RED BARN MACHINE TITLE

POWER RING EXTRACTOR

DWG NO. RBE350A93-3201-00					ev 1		
ASSY QTY	ASSY QTY	B/O	Part #	UNIT QTY	Description	Material	B/O INFORMATION OR SPECIFICATIONS	PG.	MAT'L DRAWN BY: CLOUGH UNLESS OTHERWISE SPECIFIED APPROVED DIMENSIONS ARE IN INCHES HEAT	
			-20	1	EXTRACTOR	4140 Q&T	Ø2-3/4 X 3	2	XXX ± .005 FRACTIONS + 1/32 TREAT	
			-21	1	BOLT	STEEL	M14 X 1.5 X 60mm MCMASTER-CARR #91180A381 (MODIFIED)	3	XX ± .01 ANGLES ± .5° FINISH 1. BREAK ALL SHARP EDGES .015 x 45° SPEC	
			-22	1	WASHER	1018	Ø1-3/4 X 1/2	4	OR .015R 2. DIMENSIONAL LIMITS APPLY AFTER USED ON MODEL	\neg
			-23	1	SLEEVE	DOM STEEL	Ø2-3/4 X 7/32 WALL X 15/16	5	PLATING EUROCOPTER 350	
		B/O	-24	1	PAN HEAD MACHINE SCREW	STEEL	M4 X .7 X6mm MCMASTER-CARR #92005A215	1	SCALE 1:1 DATE 3/23/2012 SHEET 1 OF	5

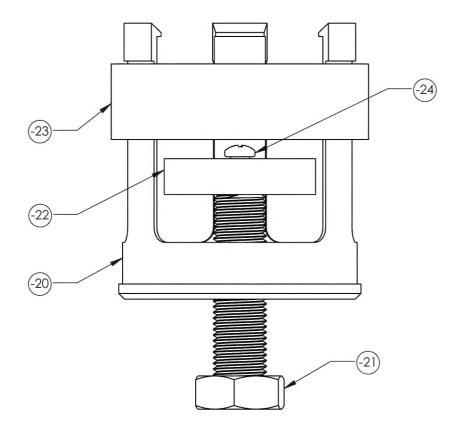
REVISIONS							
REV	DESCRIPTION	DATE	INITIAL	APPROVED			
	REDREW PRINT, CH'D -20 ANGLE FROM 60°, CH'D TIP FROM .032, ADDED -21 SCREW M4 X .7 $$.300 HOLE TO TIP, ADDED -22 MISSING .374 THICKNESS DIMENSION PER G.E.	3/26/12	RJC	GE

BOLT

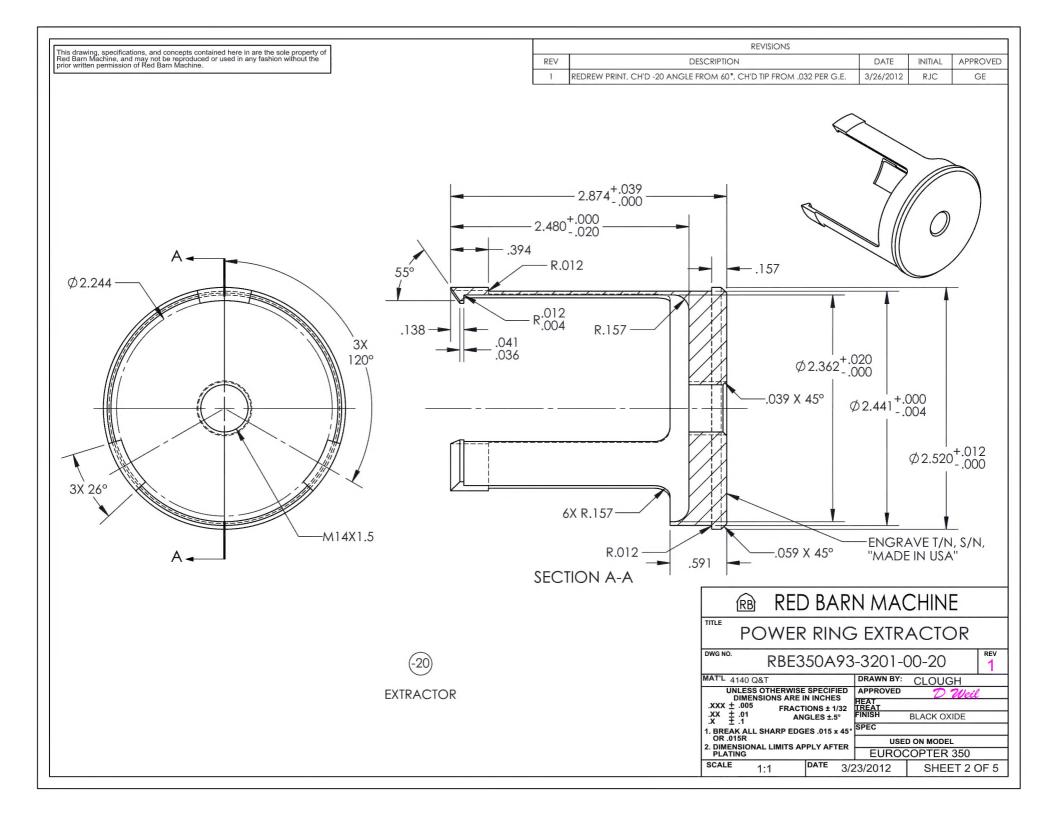
REVISIONS								
REV	DESCRIPTION	DATE	INITIAL	APPROVED				
1	ADDED -21 SCREW M4 X .7 ▼ .300 HOLE TO TIP PER G.E.	3/26/2012	RJC	GE
